# Access Compliance Report

## Public Rights-of-Way

### (Curb Ramps)

Intersection ID: 15158	Main Street: ALBEMARLE_RD	Cross Street: WILORA_LAKE_RD	Location: NE
ADA ID: 28FB8FBFCE78	Ramp Type: Perp	Initial Pass/Fail: Fail	Overall Compliance: No
Severity Score: 21.25			
Codes/Mitigation Info/Possible Solution		Field Measurements/Component Compliance

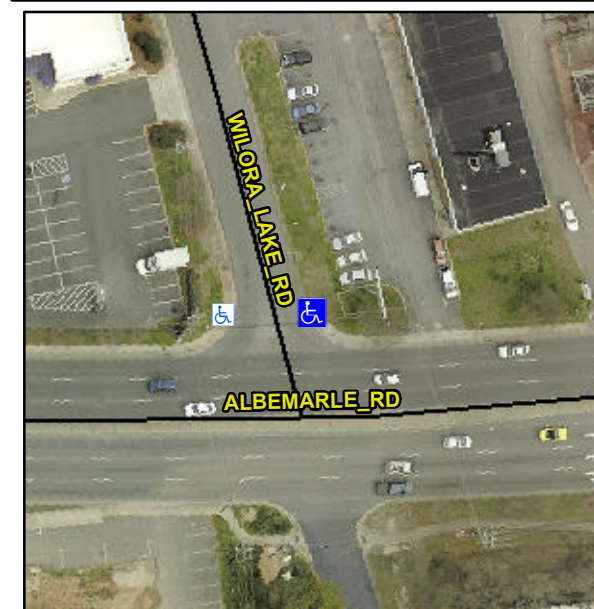
**Not Found, R304.5.1, R304.2.2**

Compliance	Description	Data	Compliance	Description	Data
N/A	Ramp Length (in)	60.0	No	Ramp Slope (%)	9.1
No	Ramp Width (in)	42.0	Yes	Ramp XSlope (%)	1.0
N/A	Flare Type LT	N/A	N/A	Flare Type RT	N/A
N/A	Flare Slope LT (%)	N/A	N/A	Flare Slope RT (%)	N/A
N/A	Flare Traversable LT?	N/A	N/A	Flare Traversable RT?	N/A
N/A	Landing Length (in)	N/A	N/A	DWS Provided?	N/A
N/A	Landing Width (in)	N/A	N/A	DWS Contrast?	N/A
N/A	Landing Slope (%)	N/A	N/A	DWS Length (in)	N/A
N/A	Landing X Slope (%)	N/A	N/A	DWS Full Width?	N/A
N/A	Landing Curb? (Y/N)	N/A	N/A	DWS Offset (in)	N/A
N/A	Shared Landing?	N/A			
N/A	Gutter Ponding?	N/A	N/A	Gutter Slope (%)	N/A
N/A	Gutter Lip Ht (in)	N/A	N/A	Gutter X Slope (%)	N/A
N/A	Painted X Walk1?	No	N/A	Painted X Walk2?	N/A
	X Walk 1 Direction	To W		X Walk 2 Direction	N/A
N/A	X Walk 1 Width (in)	N/A	N/A	X Walk 2 Width (in)	N/A
	X Walk 1 Slope (%)	0.2		X Walk 2 Slope (%)	N/A
	X Walk 1 X Slope (%)	1.8		X Walk 2 X Slope (%)	N/A

**Remove & Replace Entire Ramp.**
